Point Beach Nuclear Plant, Units 1 and 2  
Dockets 50-266 and 50-301  
Renewed License Nos. DPR-24 and DPR-27

10 CFR 50.55a Request, Relief Request RR-4L1  
Inservice Inspection Impracticality  
Examination Limitations Due to Configuration  
Fourth Ten-Year Inservice Inspection Program Interval  
Response to Request for Additional Information

#### 10 CFR 50.55a REQUEST, RELIEF REQUEST RR-4L1 INSERVICE INSPECTION IMPRACTICALITY EXAMINATION LIMITATIONS DUE TO CONFIGURATION FOURTH TEN-YEAR INSERVICE INSPECTION PROGRAM INTERVAL RESPONSE TO REQUEST FOR ADDITIONAL INFORMATION

Drawing 1  
Upper Shell to Flange (Typical both Units)

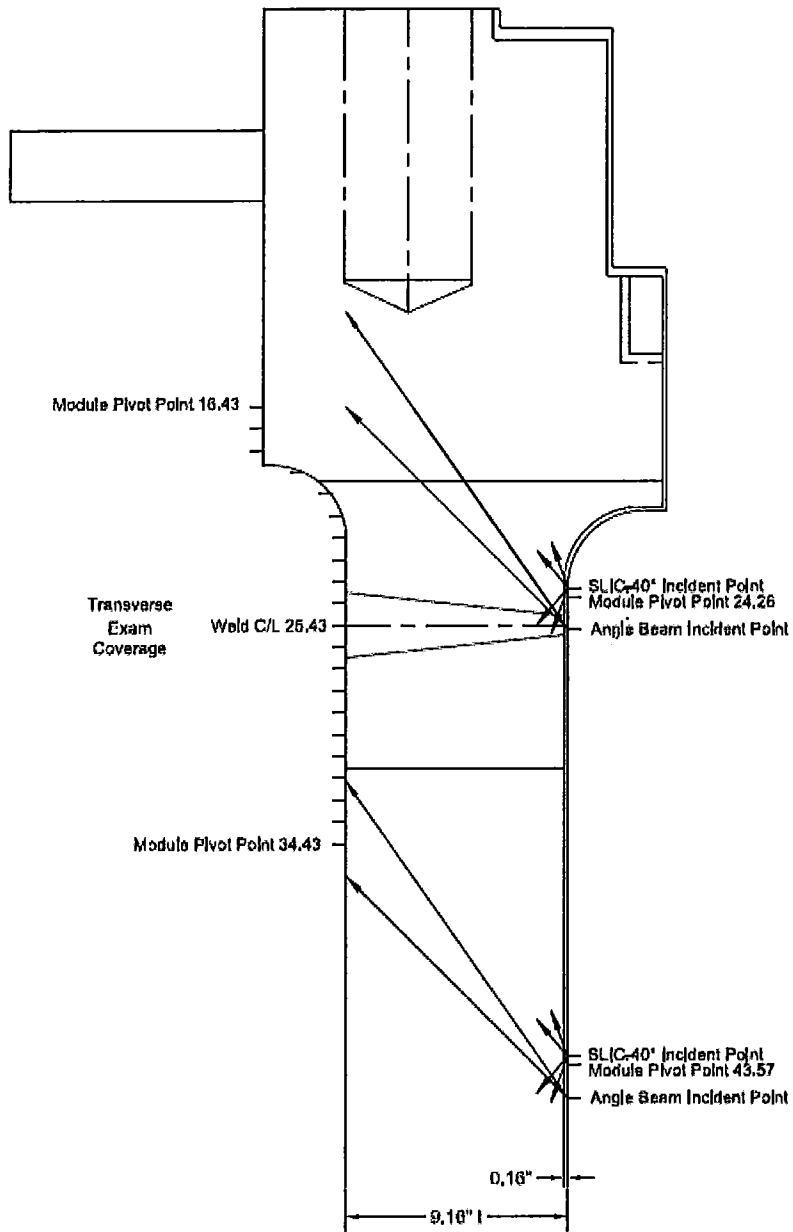
- d) *Fully clarify the wave modality and insonification angles used for all ultrasonic examinations.*
- e) *Show cross-sectional coverage plots to describe ASME Code volumes examined.*

See drawings "1" through "4" in Attachment "A" for cross-sectional drawings of the various examination areas.

### Drawing 4 Typical Both Units

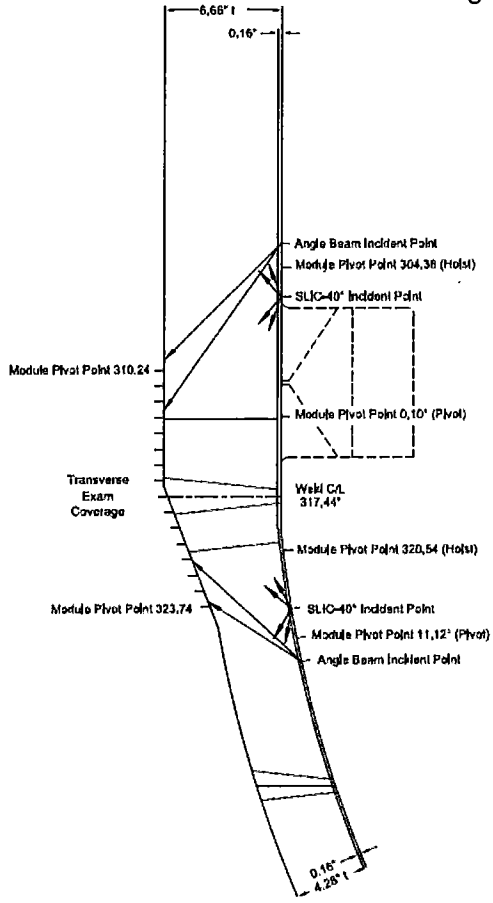
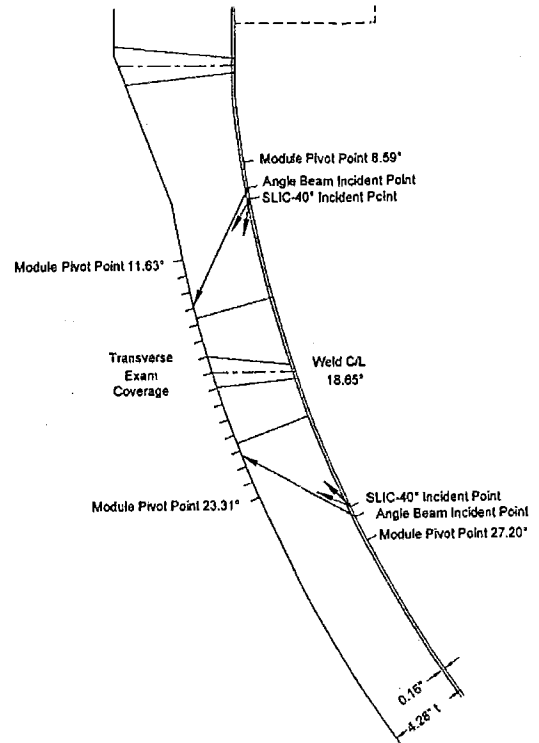
- a) *As applicable, describe nondestructive examination (NDE) equipment (ultrasonic scanning apparatus), details of the listed obstructions (size, shape, proximity to the weld, etc.) to demonstrate accessibility limitations.*

In the case of the reactor pressure vessel (RPV) Lower shell-to-lower head-ring welds (RPV-17-683), the core barrel anti-rotation lugs are mounted in such a manner that they partially obstruct accessing the weld at the four cardinal positions (0°, 90°, 180°, 270°) within the reactor vessel. These lugs are approximately 8.3 inches "tall" (measured from bottom to top of lug) and approximately 7.13 inches "long" (measured around the vessel). Each lug is attached to the RPV with welds on all four sides, which increases the distance that the scanning equipment has to be away from the lug by approximately an additional inch in each direction. See drawings "4" and "5" in Attachment "A" for a depiction of the interferences.

Drawing 9  
Unit 1 Main Steam Nozzle To Shell Configuration

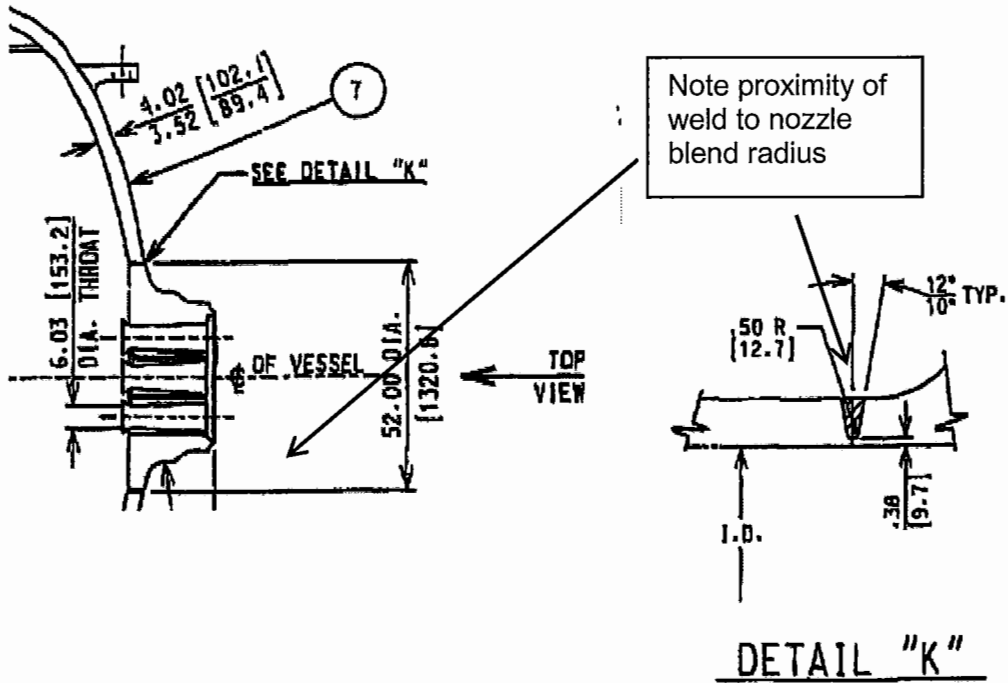
a) *As applicable, describe NDE equipment (ultrasonic scanning apparatus), details of the listed obstructions (size, shape, proximity to the weld, etc.) to demonstrate accessibility limitations.*

The NDE equipment utilized to perform the subject examinations were standard UT instruments and transducers qualified in accordance with Section XI, Appendix VIII, Supplements 4 and 6 (1998 Edition through 2000 Addenda) and demonstrated to the Authorized Inspection Agency in accordance with IWA-2240. See attachment "A" Drawing 9 for a typical drawing of a main steam nozzle to shell weld.

Drawing 10  
Pressurizer Spray and Safety Nozzle Required Examination  
Region (Typical Both Units)

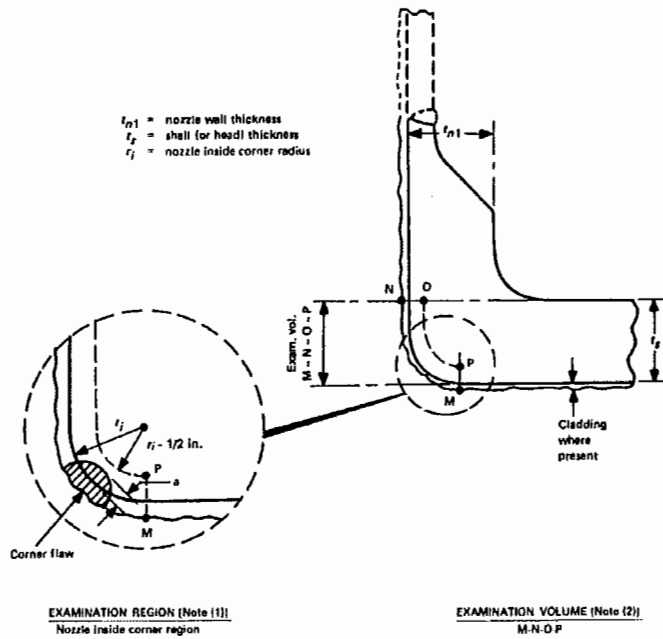
- d) *Fully clarify the wave modality and insonification angles used for all ultrasonic examinations.*
- e) *Show cross-sectional coverage plots to describe ASME Code volumes examined.*

See drawing "10" in Attachment "A" for the required examination volume.
